ENCLOSURE 4

PROPOSED CHANGE TECHNICAL SPECIFICATION PAGES

H.B. ROBINSON Unit #2
Carolina
Power & Light Company
Technical Specifications

**FIGURE
3.10-1**

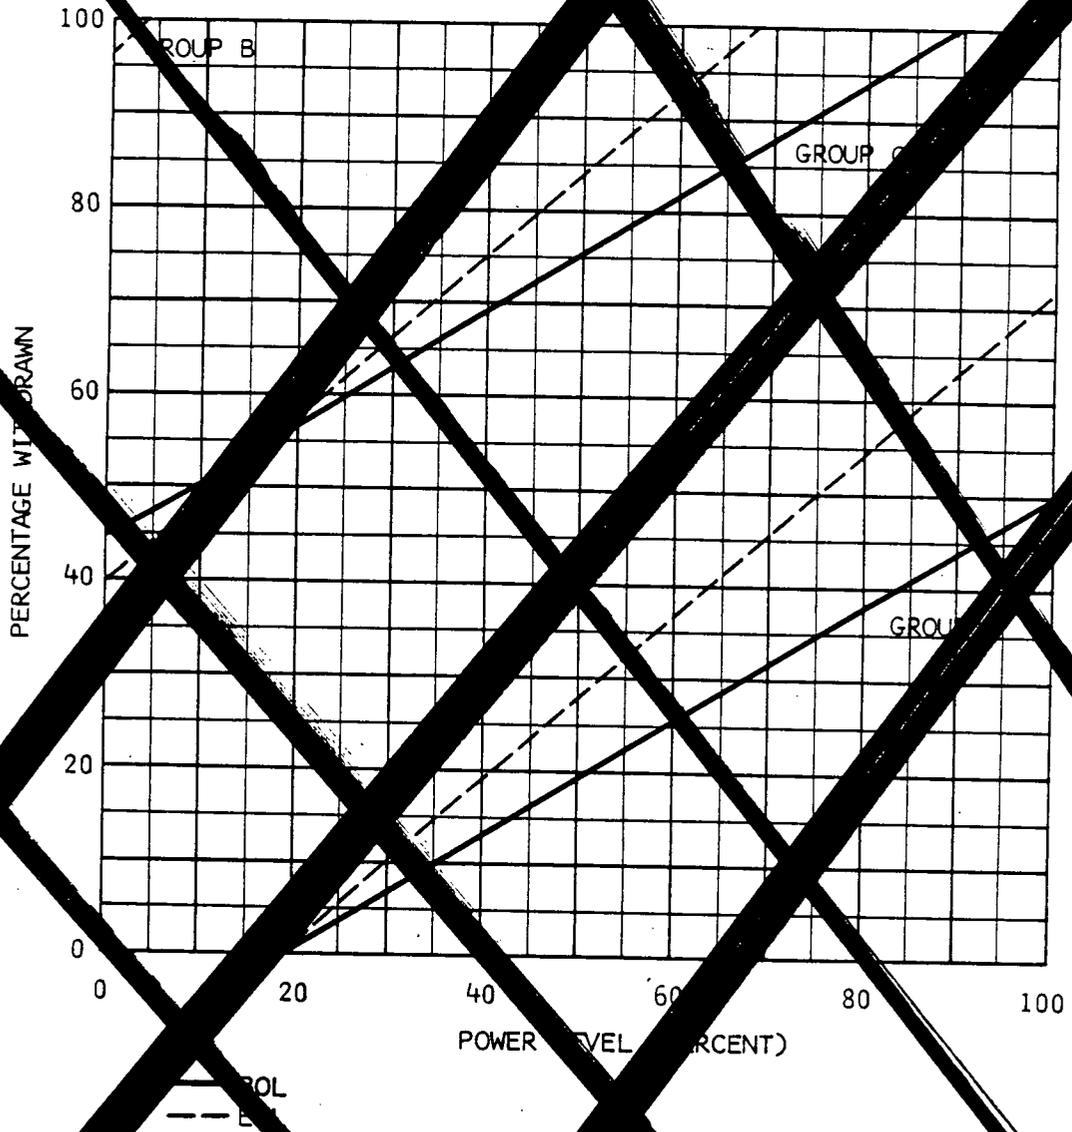
3.10.1.3 When the reactor is critical, except for physics tests and full length control rod exercises, the control rods shall be no further inserted than the limits shown by the solid lines on Figure 3.10-1 for three-loop operation. ← limited in physical insertion as specified in the COLR.

3.10.1.4 At 50 percent of the cycle as defined by burnup, the limits shall be adjusted to the end-of-core values as shown by the dotted lines on Figure 3.10-1. ← specified in the COLR.

FIGURE 3.10-1 DELETED

The control rod insertion limits are specified in the CORE OPERATING LIMITS REPORT (COLR) and are appropriately chosen to meet the shutdown requirements shown in Figure 3.10-2.

FIGURE 3.10-3 NORMALIZED AXIAL DEPENDENCE FACTOR FOR F_q VERSUS ELEVATION (PEAK $F_q = 2.32$)

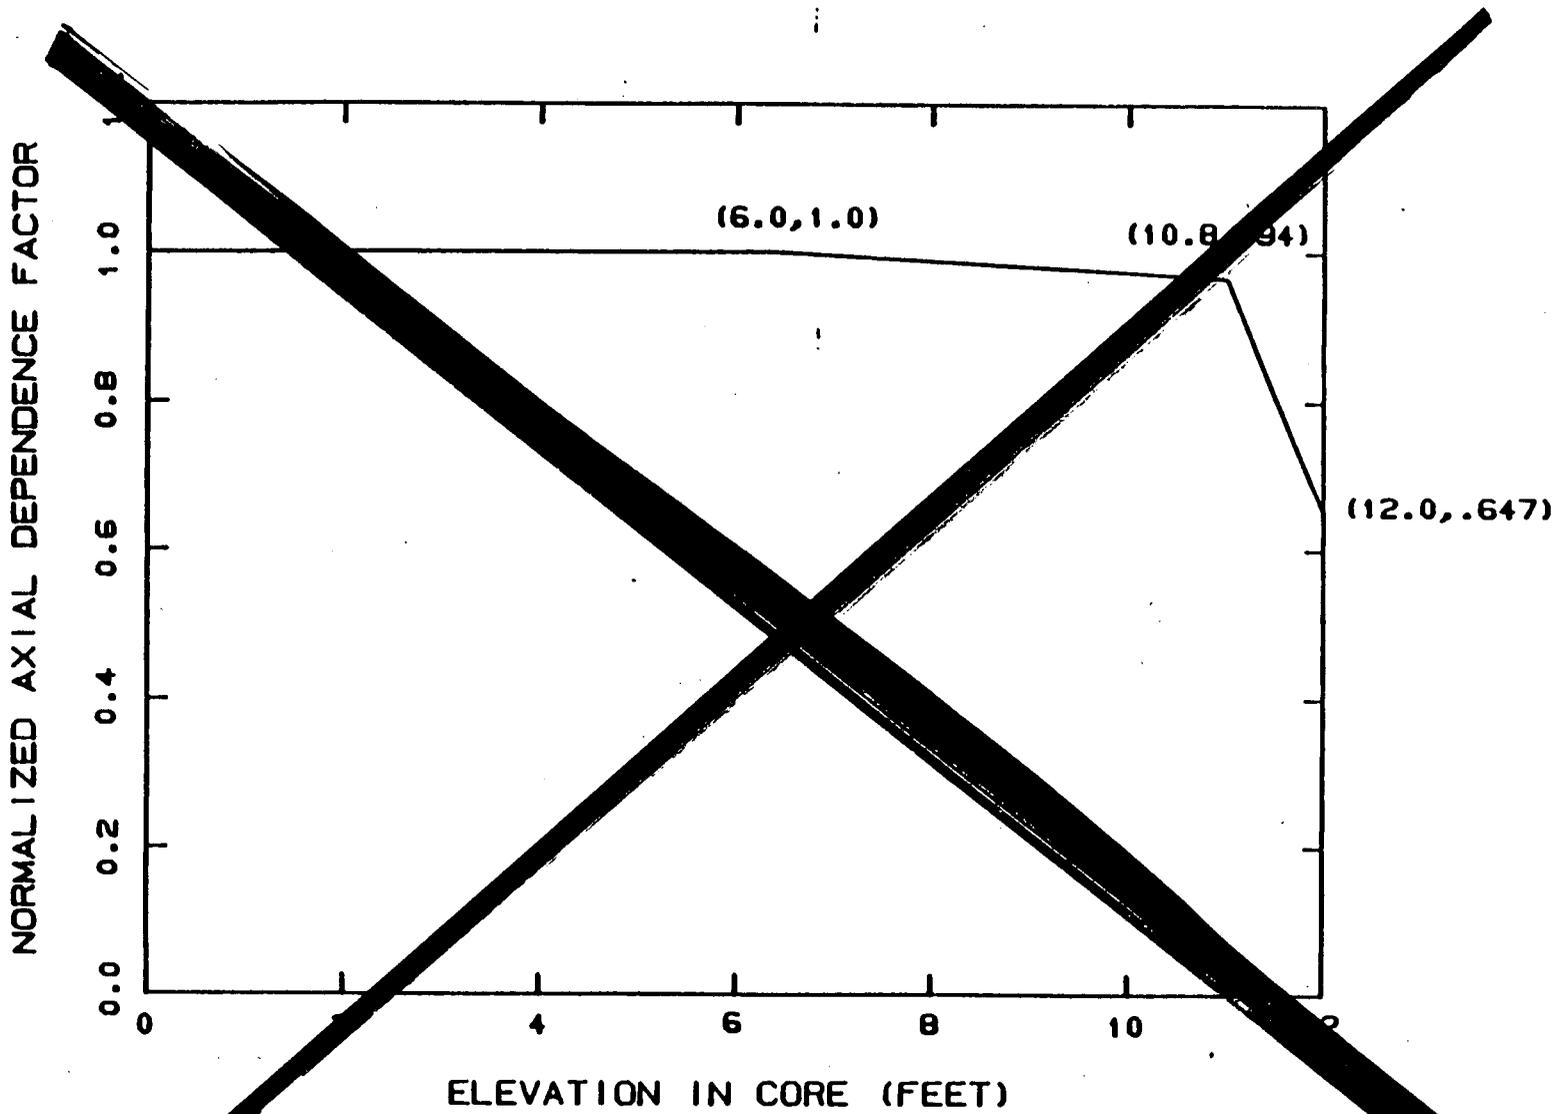
FIGURES 3.10-3 THROUGH 3.10-5 DELETED

The $V(Z)$ axial variation function and $K(Z)$ functions are specified in the COLR.

Figure 3.10-4

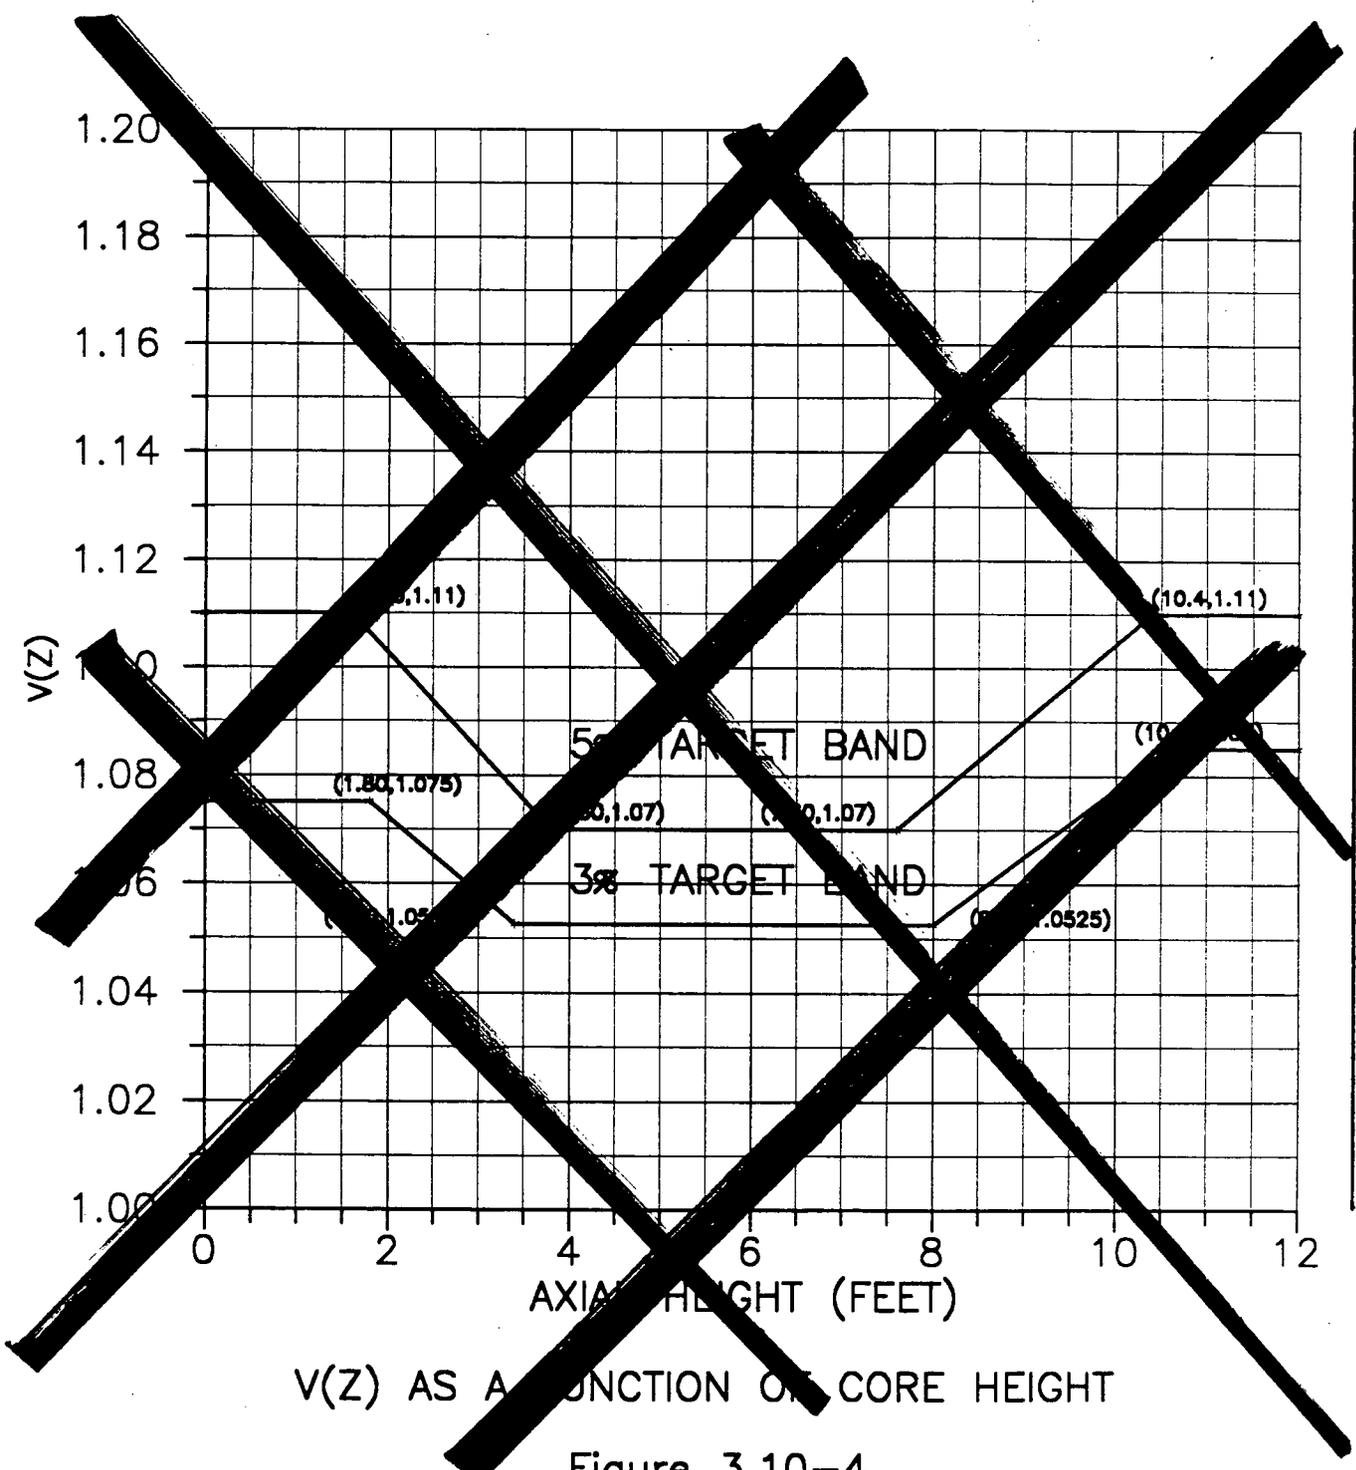
FIGURE DELETED

ALLOWABLE DEVIATION FROM TARGET FLUX DIFFERENCE
Figure 3.10-5

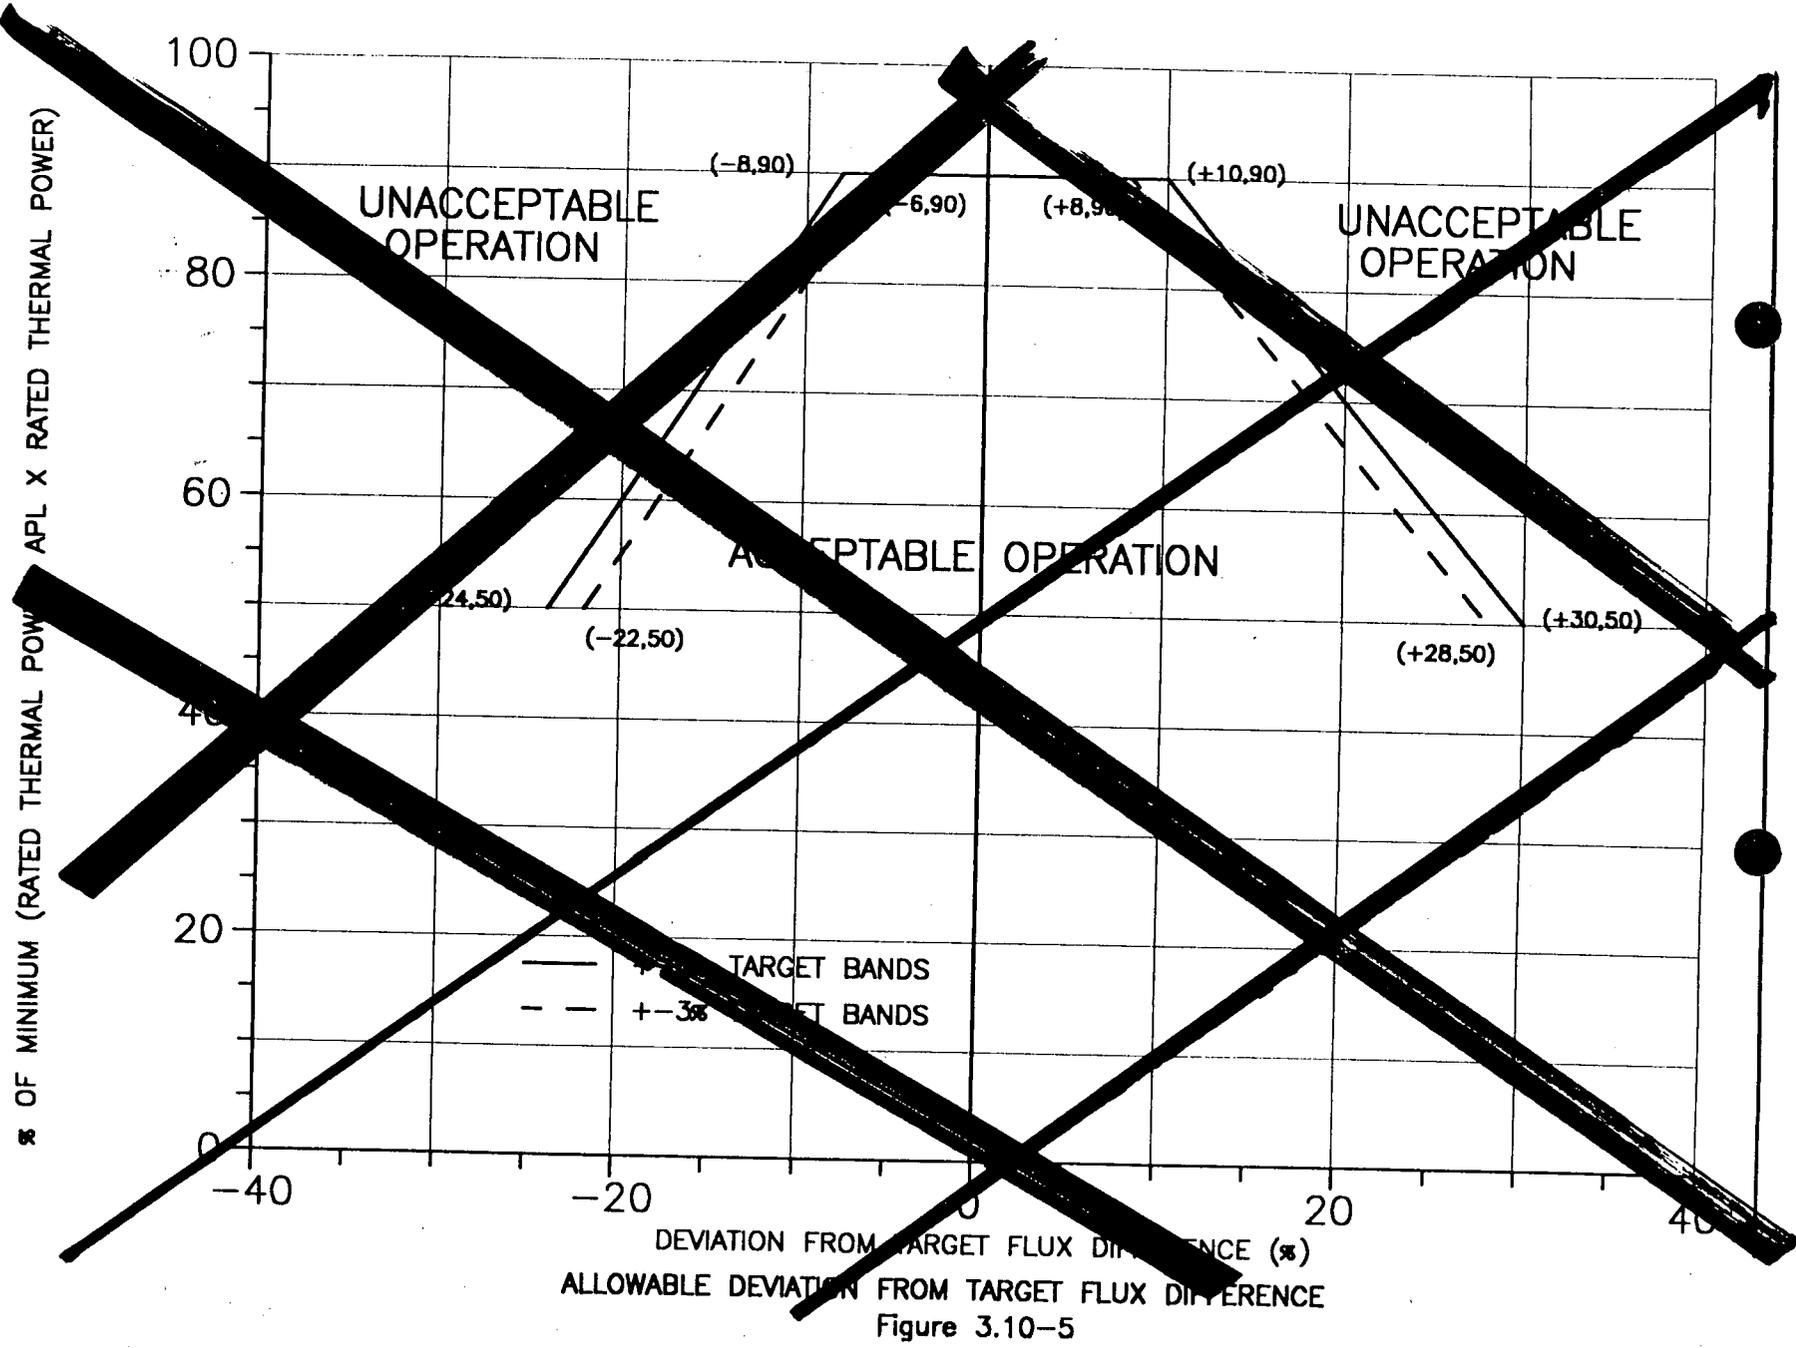
FIGURE DELETED

3.10.2.11 The axial flux difference target band about the target axial flux difference shall be determined in conjunction with the measurement of $F_Q(Z)$ as specified in 3.10.2.1.1. The allowable values of the target band are shown in Figure 3.10-5. *specified in the COLR.* Redefinition of the target band from more restrictive to less restrictive ranges between determinations of the target axial flux difference is allowed when appropriate redefinitions of APL are made. Redefinition of the target band from less restrictive to more restrictive ranges is allowed only in conjunction with the determination of a new target axial flux difference.
